## BRP/8 Barrowland Lane bridge, near Toller Porcorum, Dorset

## **BRP/8 Barrowland Lane bridge: Engineering Appraisal**

By Alan Hayward FEng CEng FICE FStructE

Figure 7: Sketch BL-1 showing two alternatives for stabilisation of the east abutment.

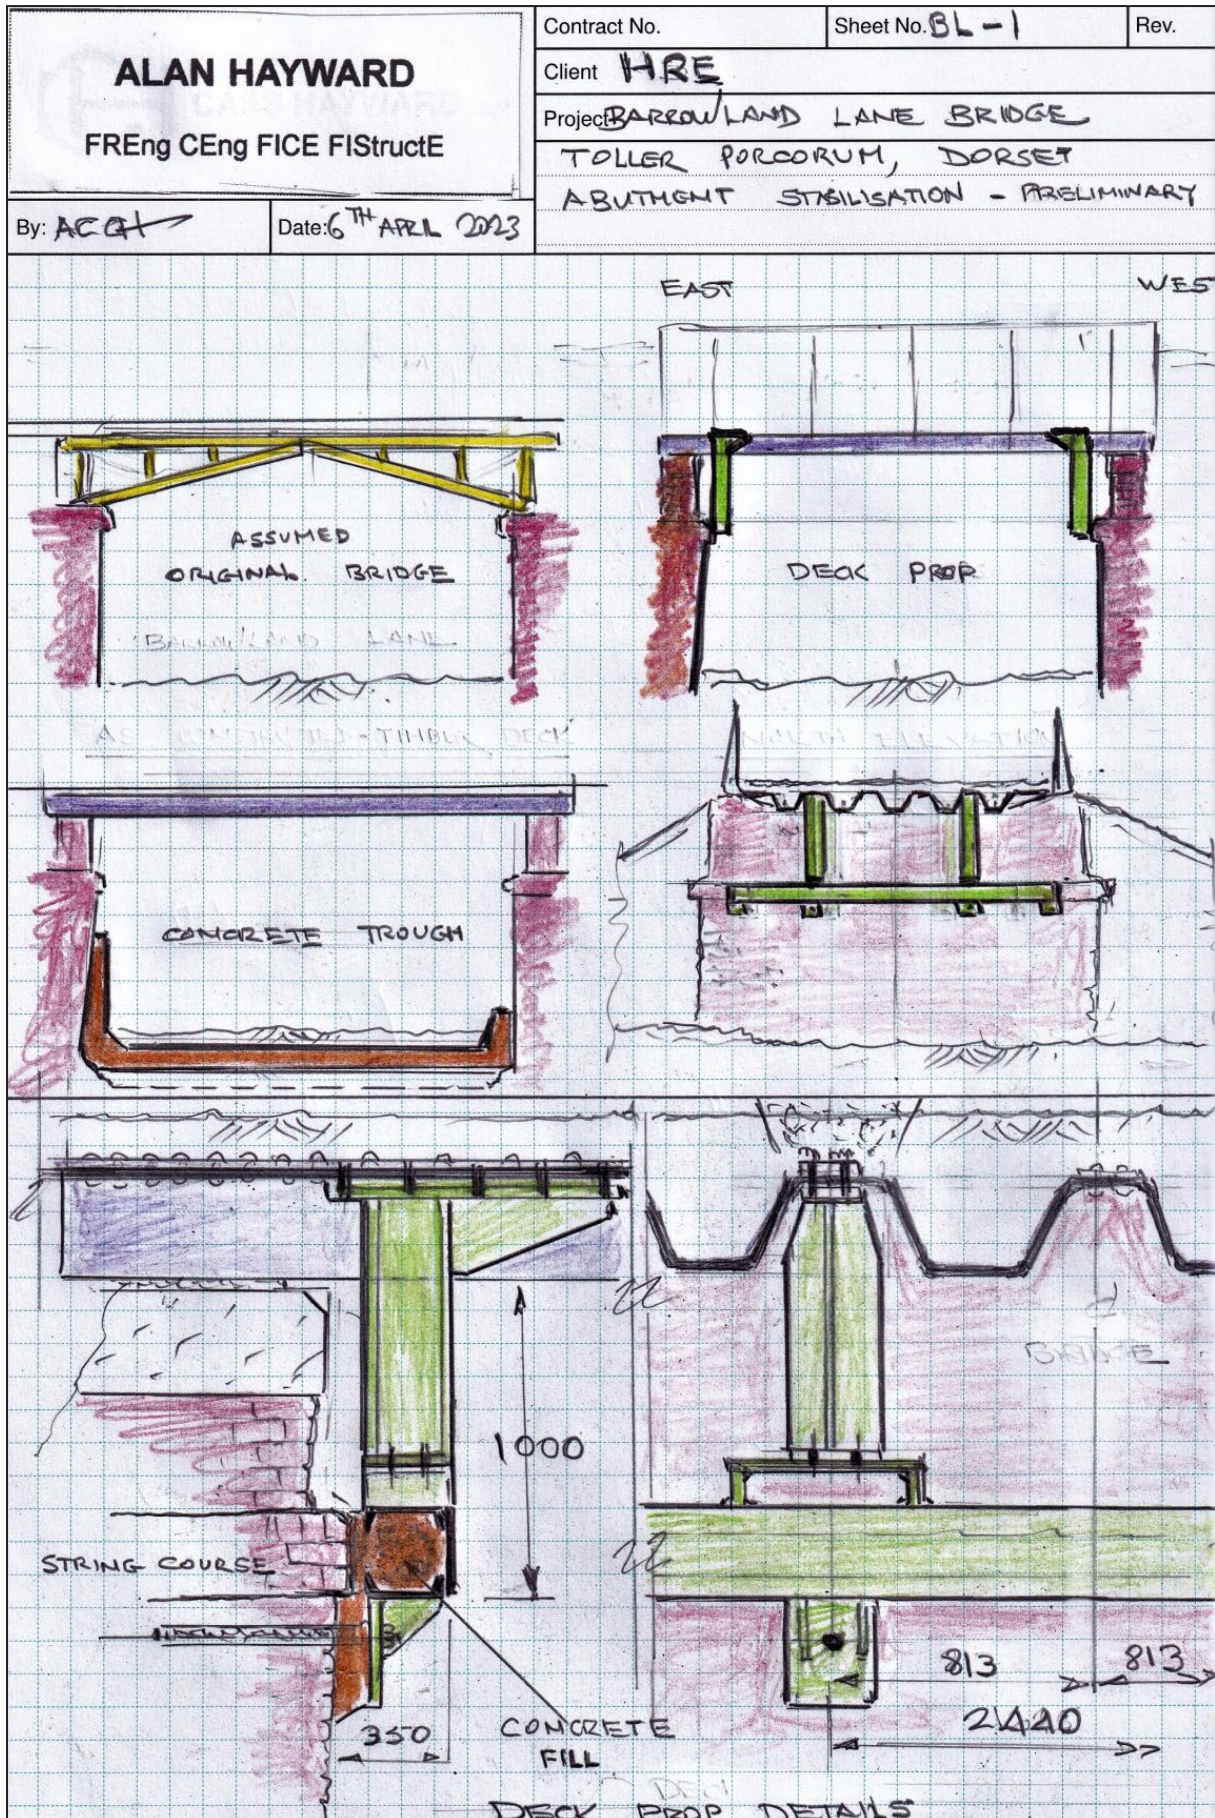
- 5.1 In order to preserve stability of the east abutment stabilisation options should be considered. Sketch BL-1 (See Figure 7) shows two alternatives as in 5.2 and 5.3.

A reinforced concrete trough would be constructed within the roadway, taken up to suitable height to restrain the east abutment. At the west abutment the trough could form a kerb so minimising roadway restriction, or be taken up to height as for the east side. The slab beneath the roadway could incorporate a downstand at each end to prevent floodwater ingress.

Restraint would be achieved by propping at the string course level with steel spreader beams, connected by two brackets at each abutment to the trough deck above. The spreader beams would be secured to the abutment walls and with infill concrete cast against the string course. The brackets would be connected to the trough top flanges with bolting access from above. An indicative calculation shows that troughs with a 12.7mm [0.5 in] thickness would have more than sufficient capacity to resist the forces from "at rest" earth pressures including surcharge. Connection between spreader beam and bracket would incorporate vertical flexibility to allow for deflection of the deck under live loading. This option would minimise restriction to roadway clearance.
